Thrumster Wastewater Scheme - Response to Submissions - Request for Additional Information

Our ref: Thrumster Wastewater Scheme (SSI-56980459)

Subject: Request for Additional Information

Figure 1: Downstream view of the Partridge Creek wetlands hydraulic weir. Top water level of the wetlands is set at 1.4m AHD (top of weir gate in image).

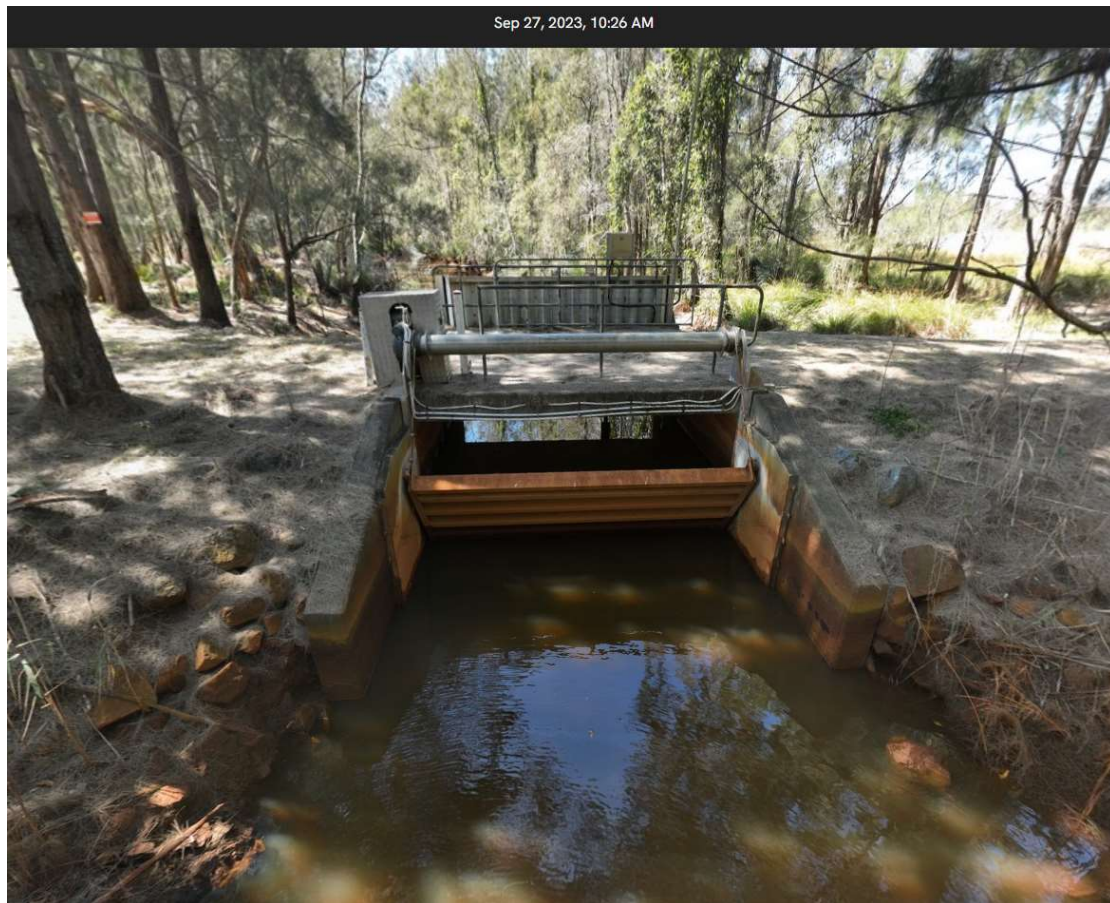
1. Please provide information in what scale flood events discharges to Partridge Creek are likely to occur (ie X AEP event).

Storm overflows from the Thrumster Wastewater Treatment Plant will be directed into the Partridge Creek wetlands upstream of the hydraulic weir that controls releases into the channel that flows to Fernbank Creek. The operation of the hydraulic weir is set to manage acid sulphate soils within the wetland area and has two set points. The default automatic set point for the weir is a height of 0.9m Australian Height Datum (AHD). Should the pH of the wetland waters drop below 5 then the weir height is raised to 1.4m AHD to ensure any acid sulphate soils remain submerged to reduce the risk of oxidation. The pH is automatically monitored via an online instrument with the weir height adjustment also automated within Council Supervisory Control and Data Acquisition (SCADA) system. Therefore, any overflows from the treatment plant into the wetlands will not increase the flows within the channel to Fernbank Creek as the weir will always control the release at a fixed volume from the wetland.

The height control of the hydraulic weir is shown below in Figure 1.

Figure 3.1 Identified sensitive receivers for Partridge Creek HDD (Aerial: Nearmaps – taken 28/10/25)

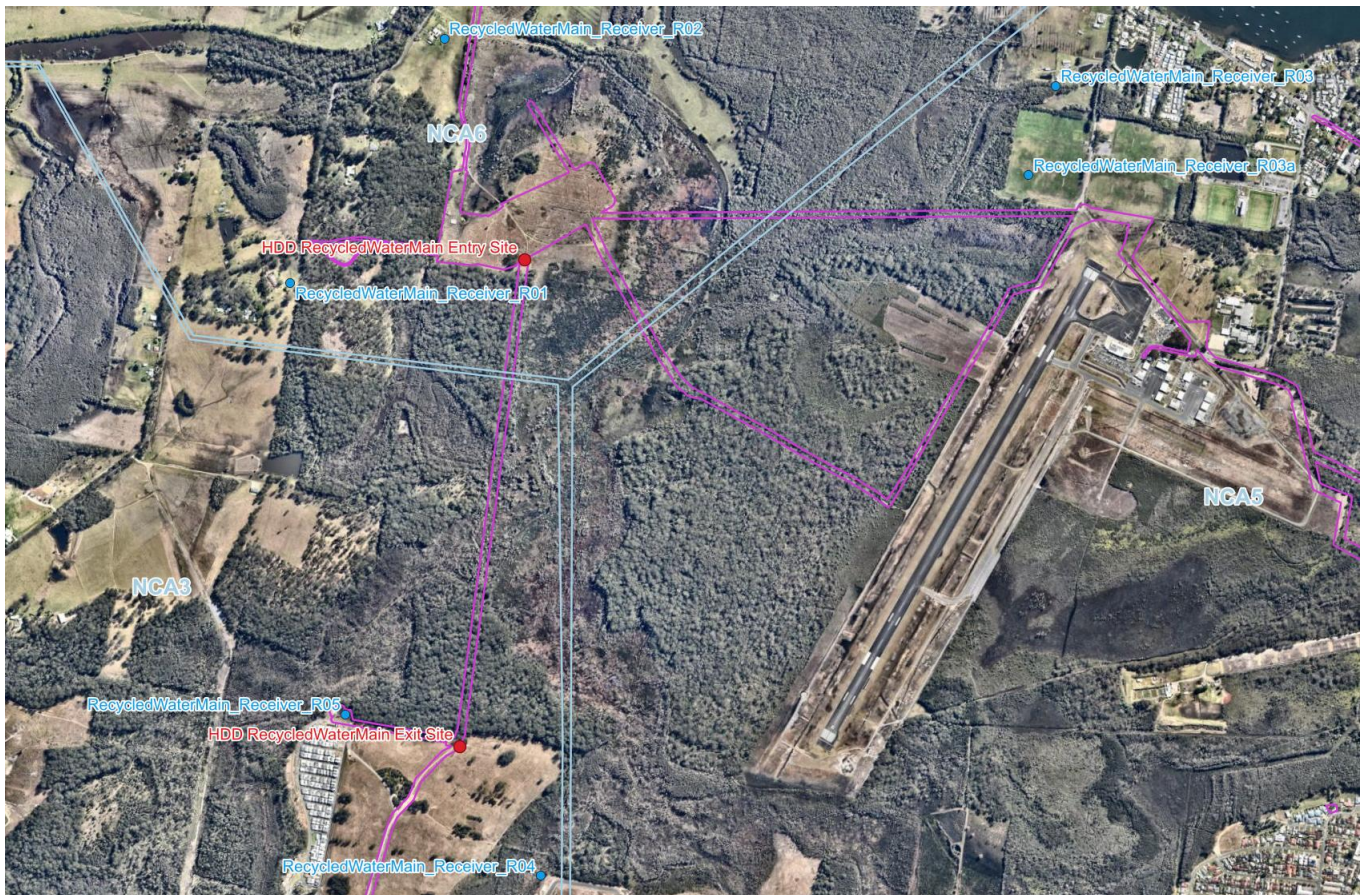
4. Please confirm how the large HDD underbores proposed from the WWTP beneath the surrounding protected land would be undertaken within the standard construction hours.
5. If 24 hour work is proposed (or needed) to undertake HDD bores, please provide a document that assess the potential noise impacts that would occur as a result of the proposed 24 hour works. Note, this should assess the impacts (ie likely sleep disturbance etc), not just provide a predicted noise level.

The previous noise and vibration assessment (GHD, 2024) identified noise impacts across designated Noise Catchment Areas (NCAs). The trenchless pipe installation activities will be located within NCA 3, NCA 5 and NCA 6. To better understand the potential noise levels at nearby sensitive receivers, a selection of representative locations were identified to reflect those most likely to be impacted by the trenchless pipe installation activities. They are summarised in Table 3.1 and shown visually in Figure 3.1 to Figure 3.6.
